Attachment 3

Mark-ups of Affected Technical Specifications Pages
and Proposed Replacement Curves
for the Request for Revision to the Pressure-
Temperature Curves (PCOL 96/10)
for
Grand Gulf Nuclear Station

GNRO-96/00120

FIGURE 3.4.11-1

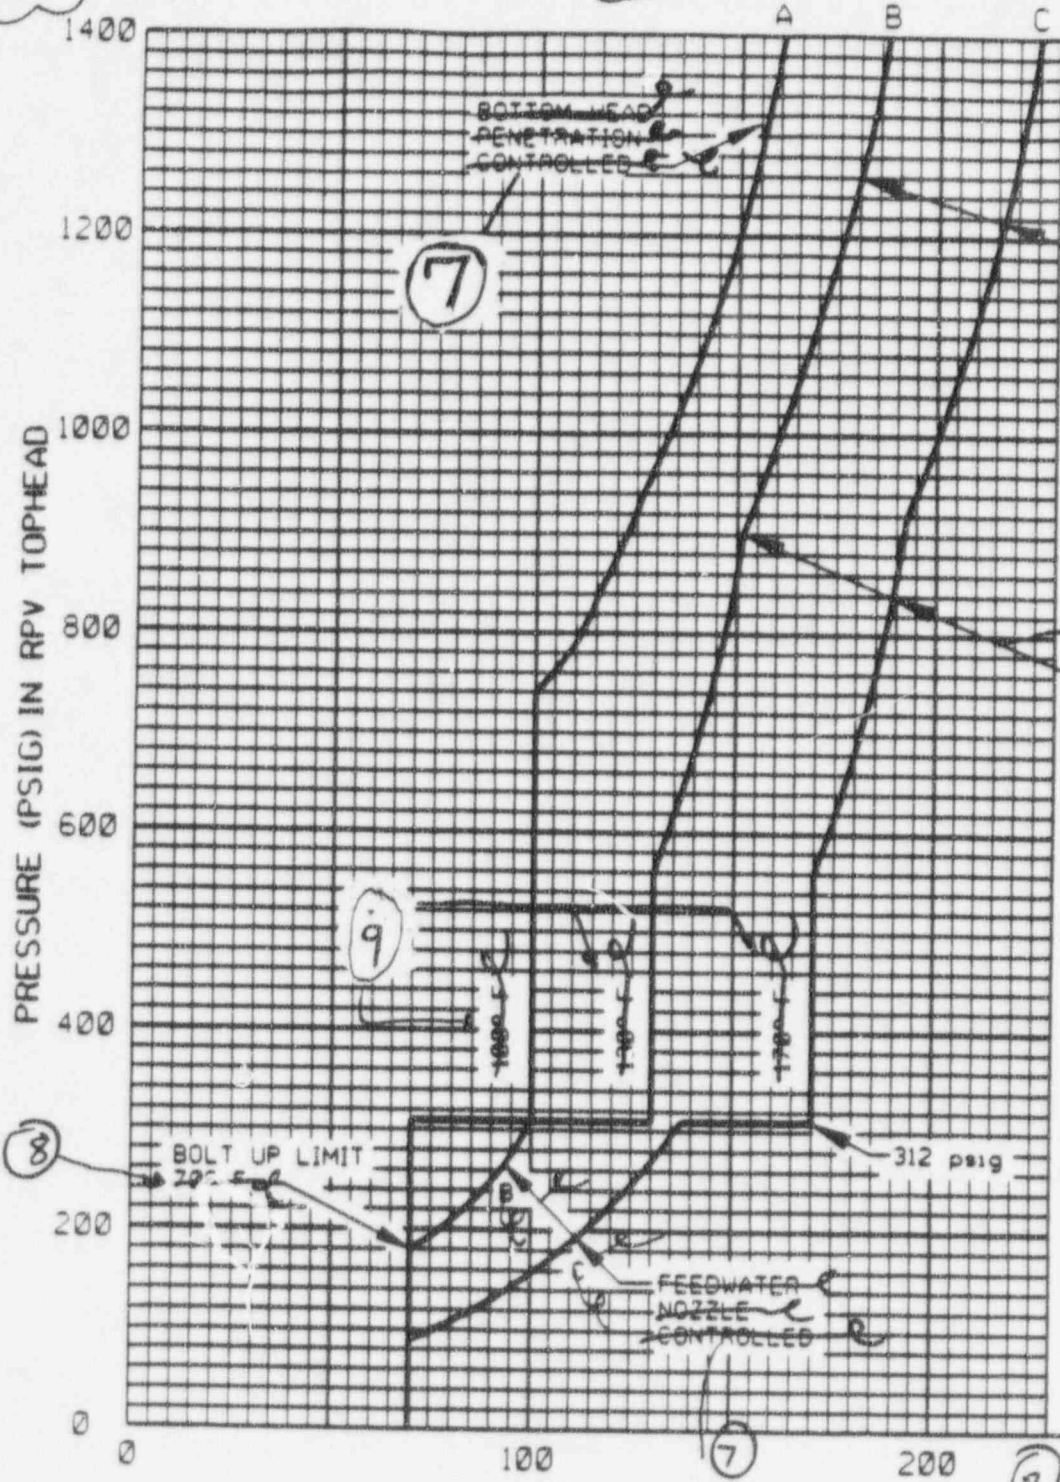
- A - INSERVICE LEAK AND HYDROTEST
- B - ~~NON-NUCLEAR~~ HEAT UP & COOLDOWN LIMIT
- C - ~~NUCLEAR (CORE CRITICAL)~~ HEAT UP & COOLDOWN LIMIT

CURVES B & C ARE
BASED ON AN ART
OF 25.76 OF
OF BELTLINE.
CURVE A IS NOT
BELTLINE CONTROLLED.

CURVES A, B & C ARE
PREDICTED TO BE
APPLICABLE FOR SERVICE
PERIODS UP TO AND
INCLUDING 10 EERY.

see Attached
Replacement
CURVES

Figure 3.4.11-1 (page 1 of 5)

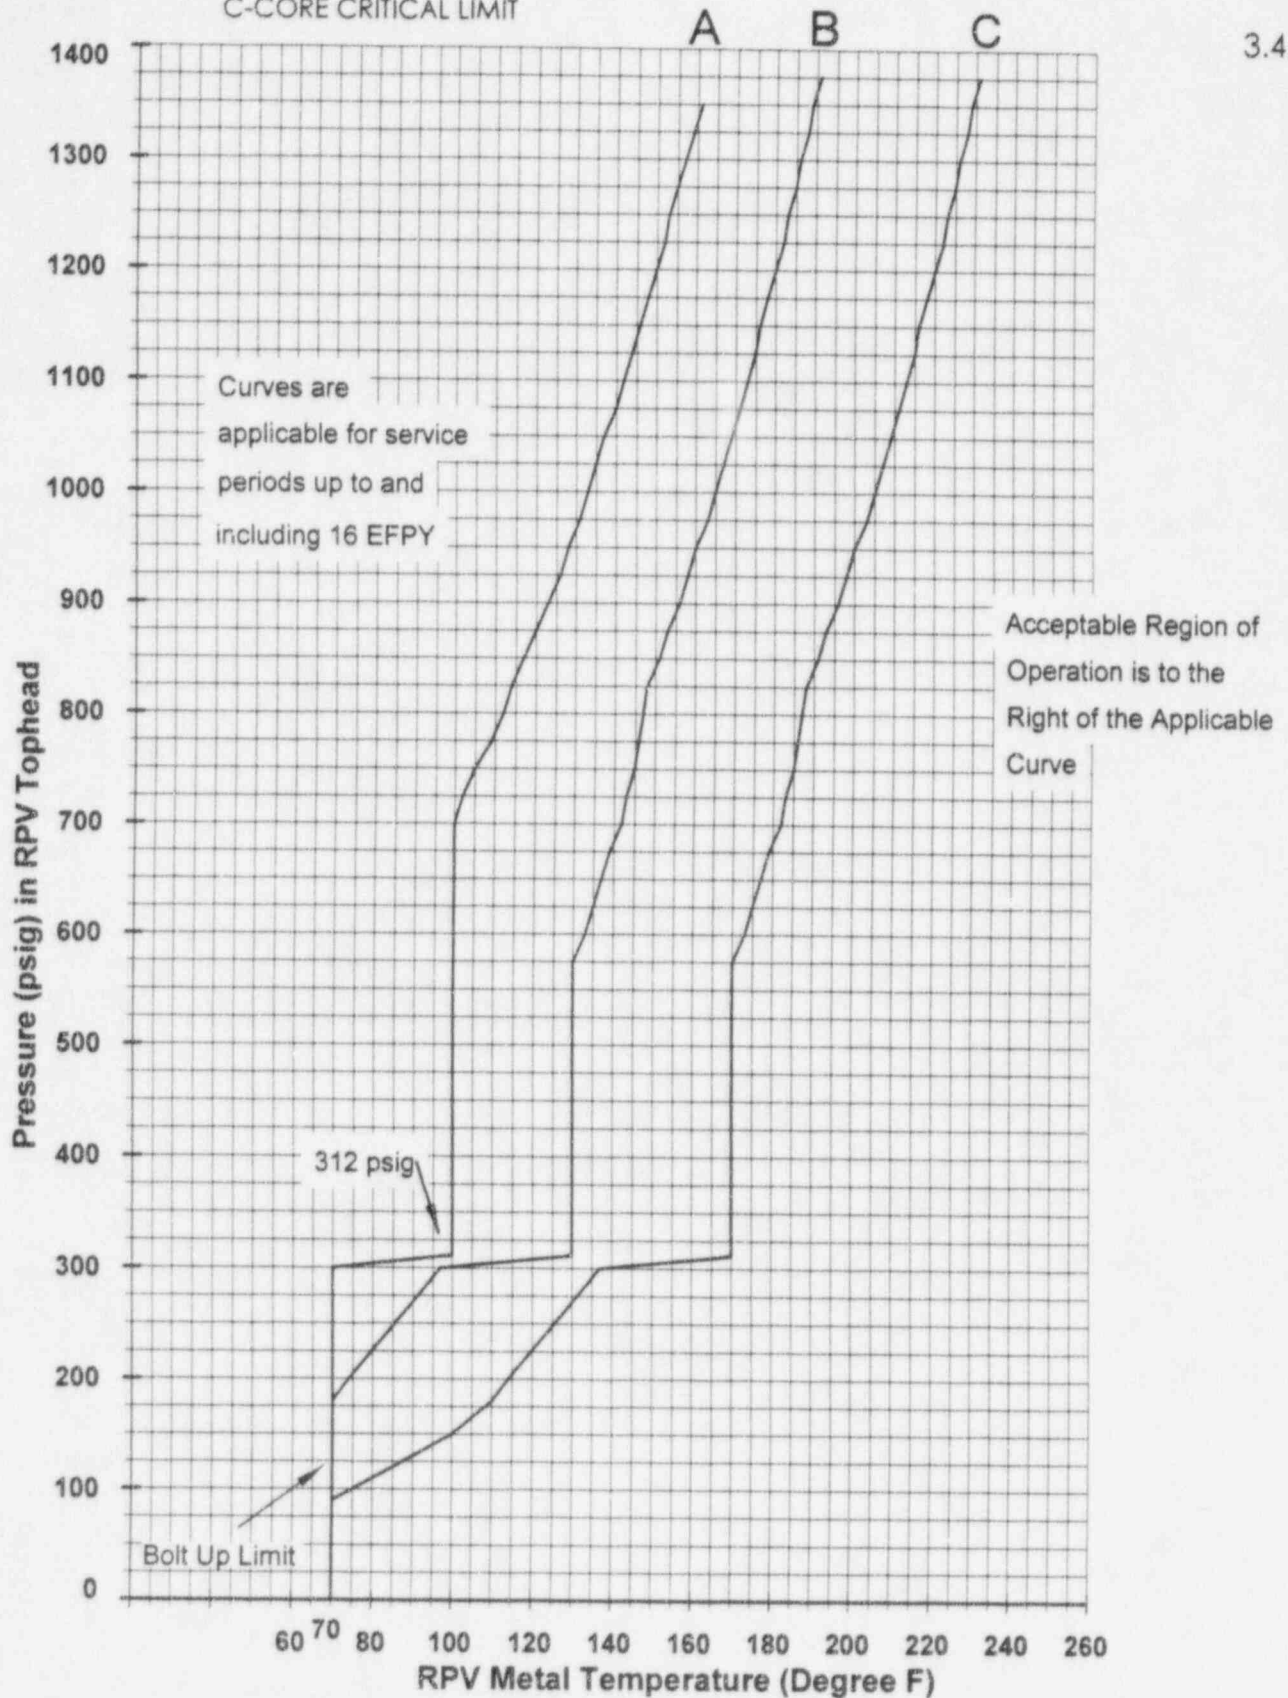
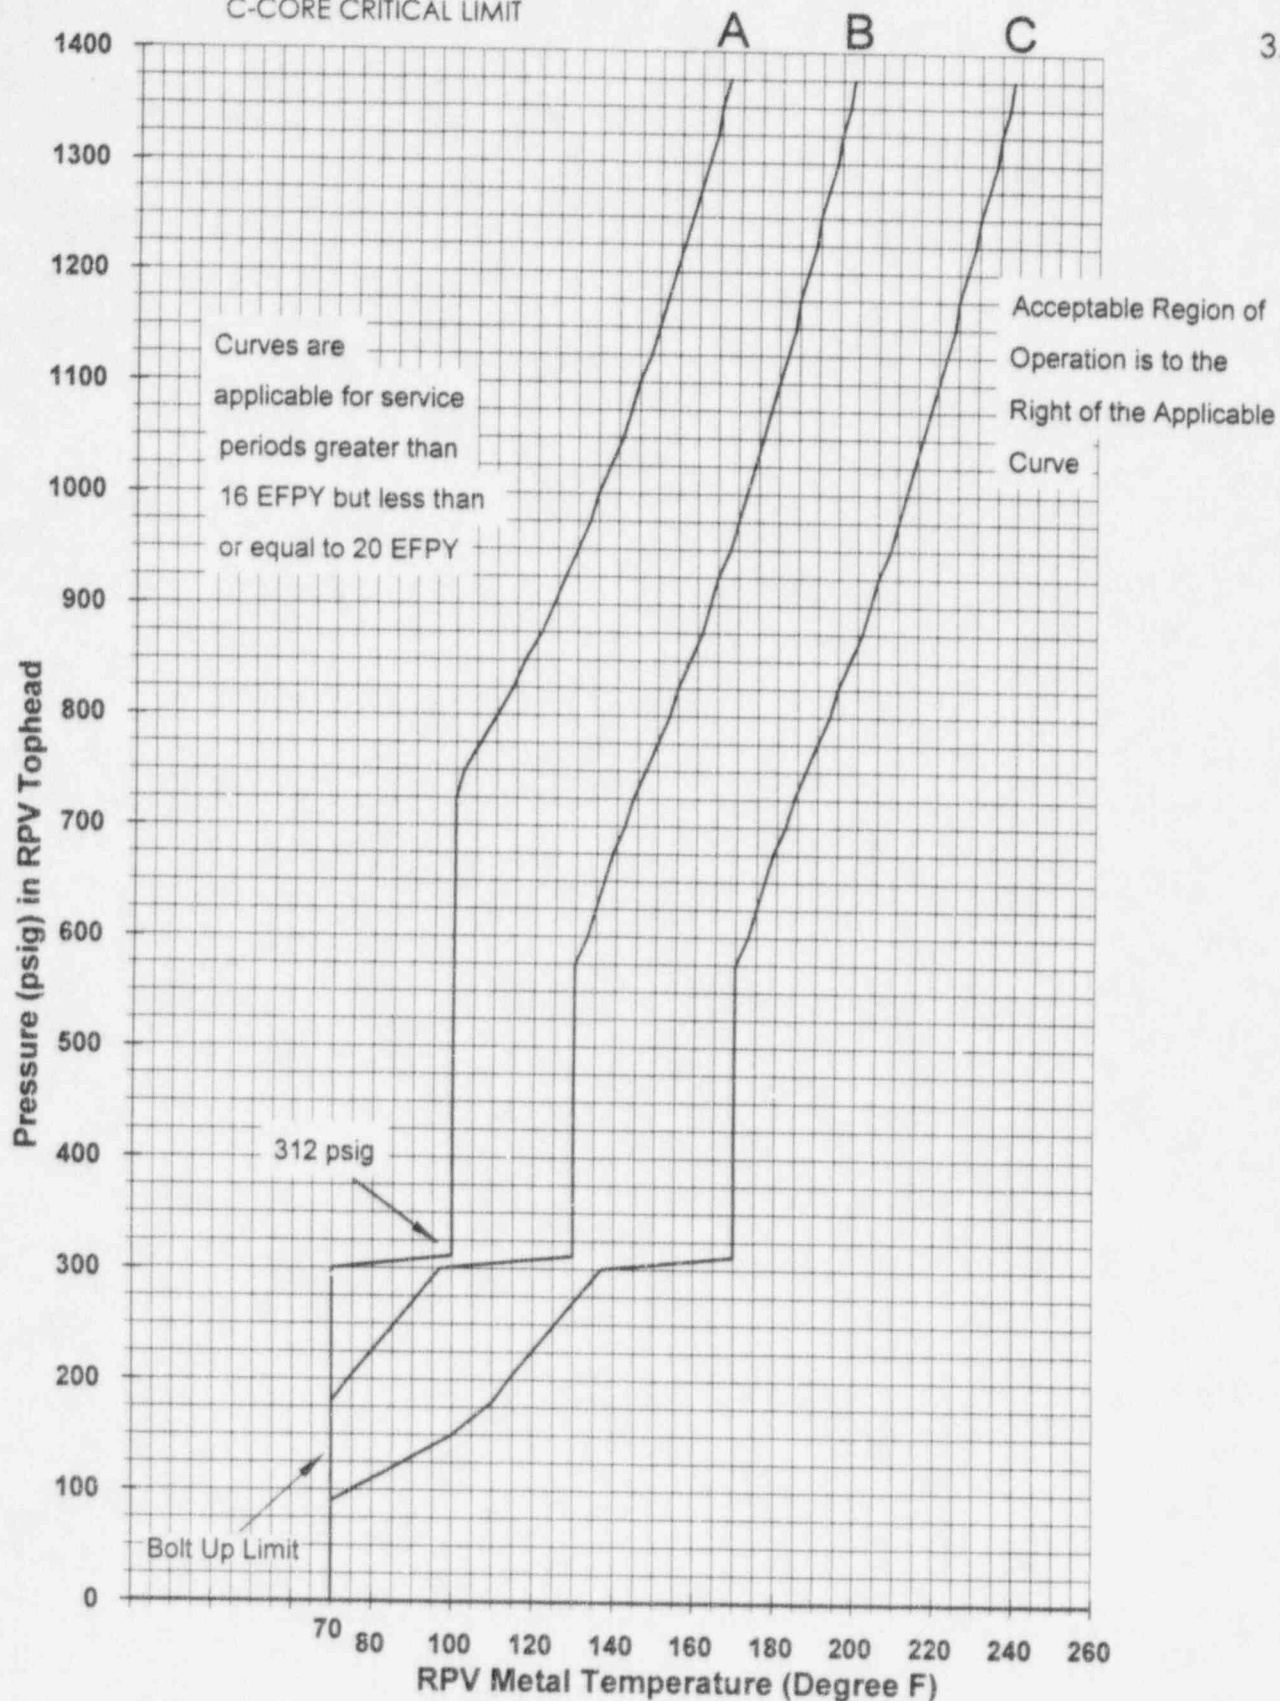
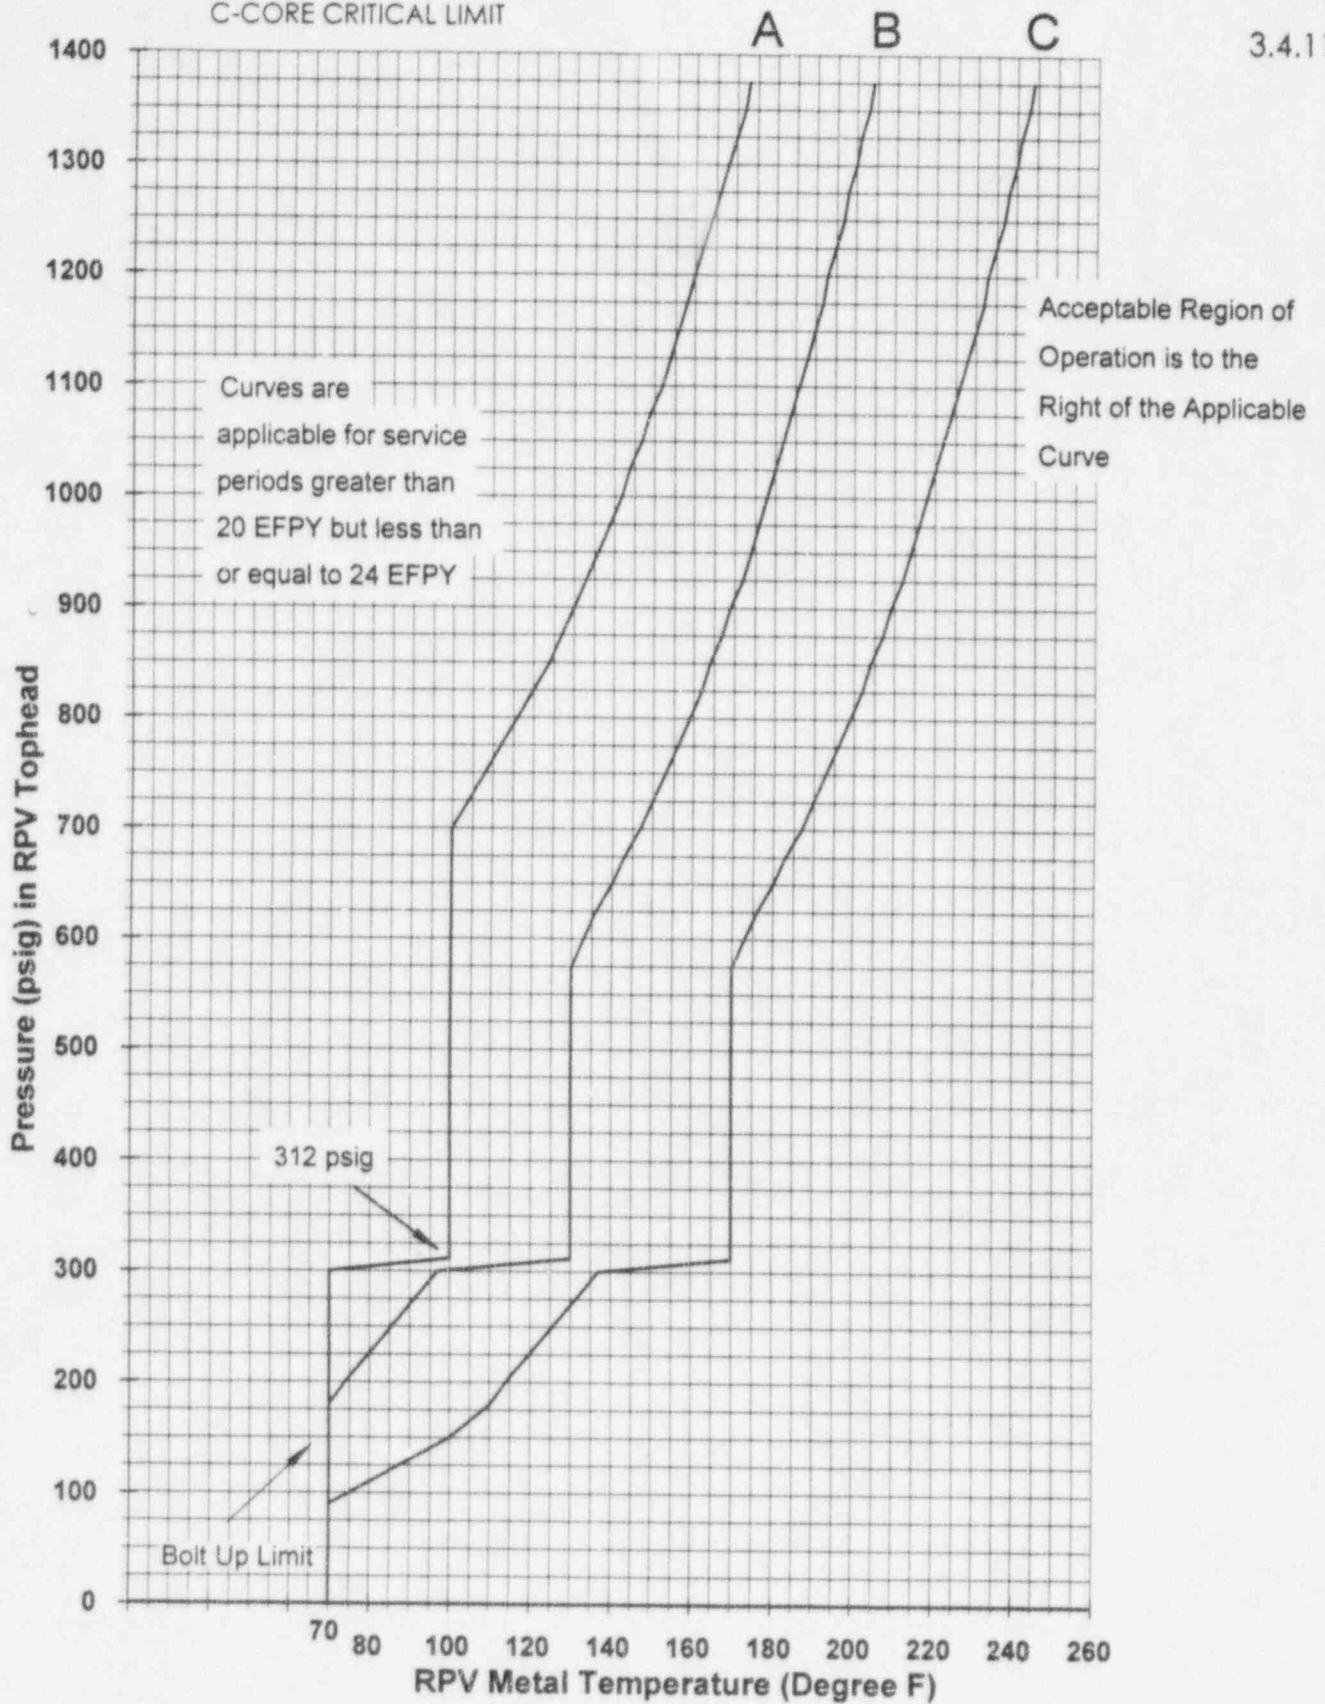
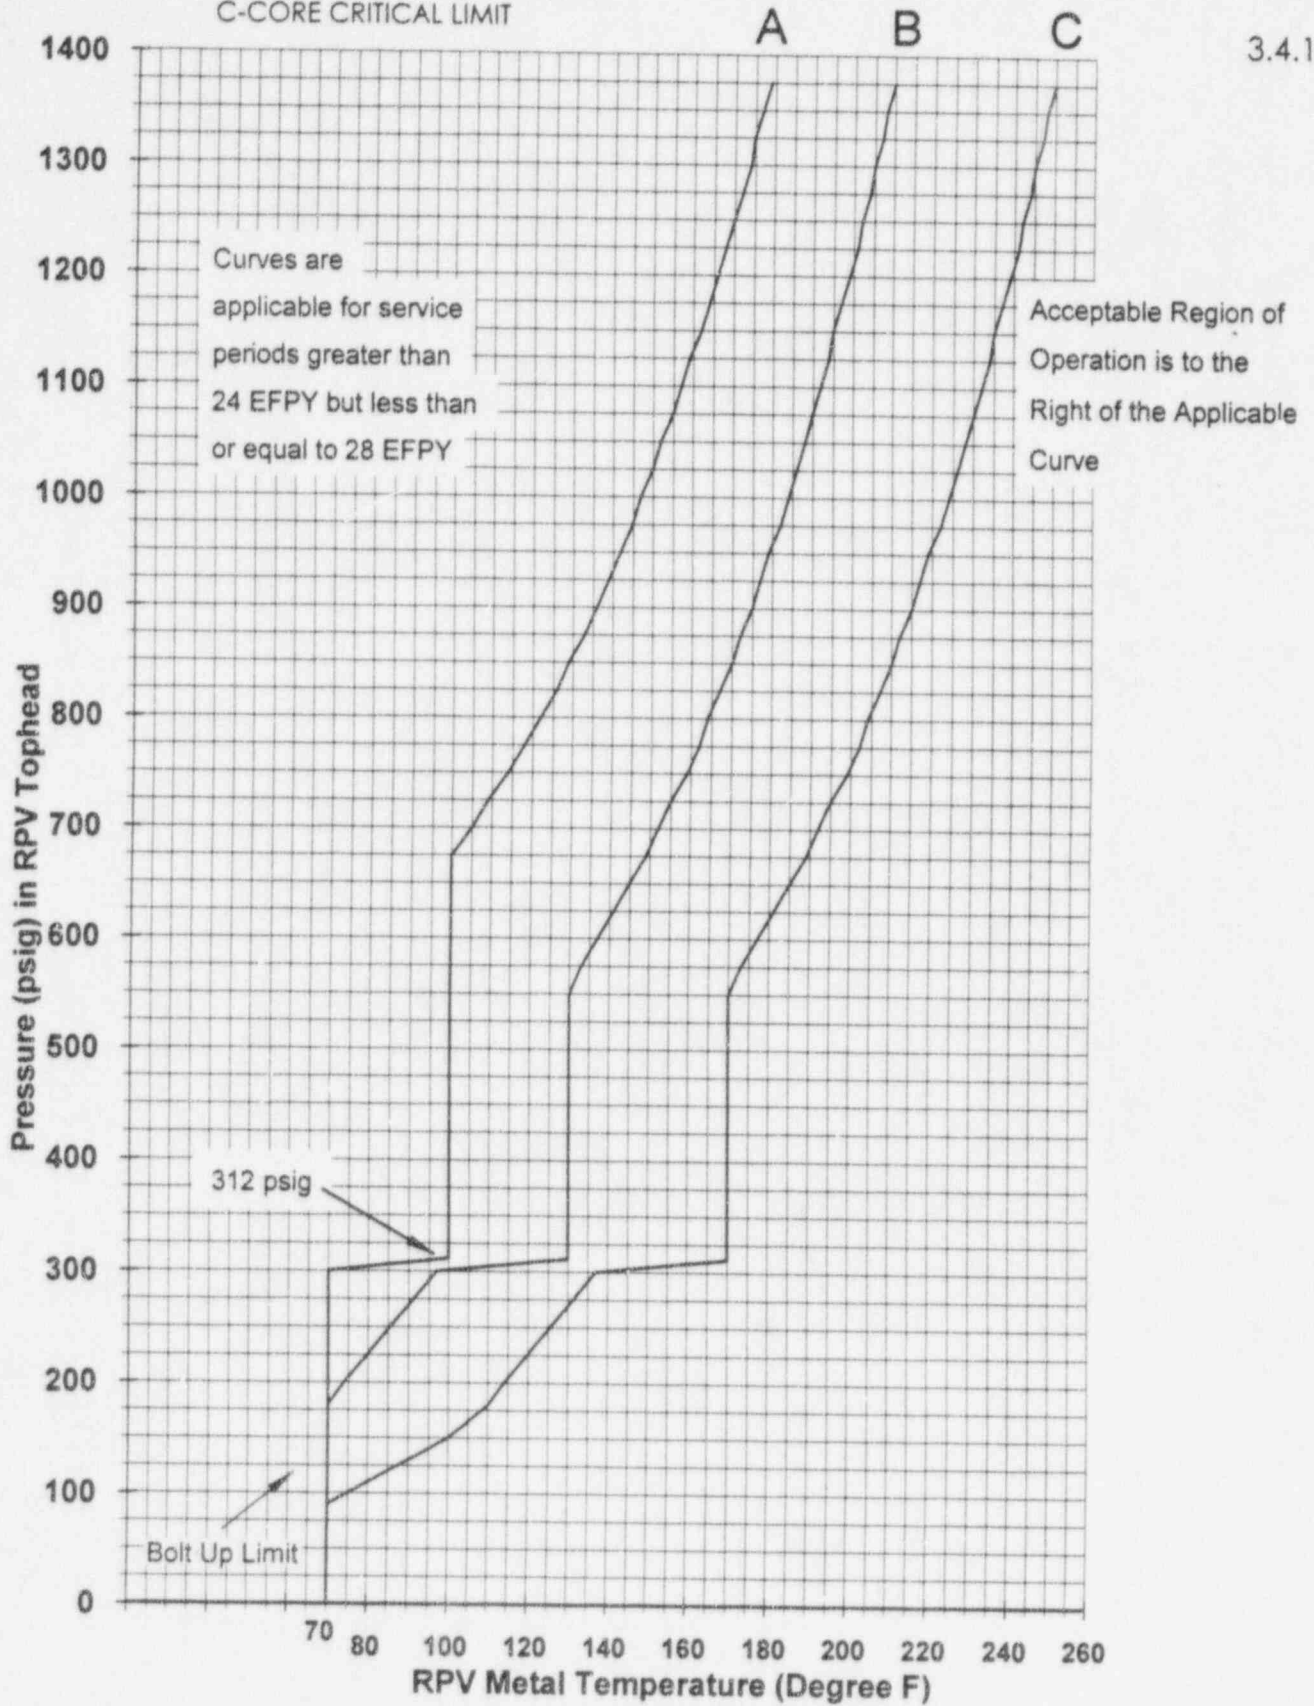
A-INSERVICE LEAK & HYDROSTATIC TESTING LIMIT
B-CORE NOT CRITICAL LIMIT
C-CORE CRITICAL LIMIT
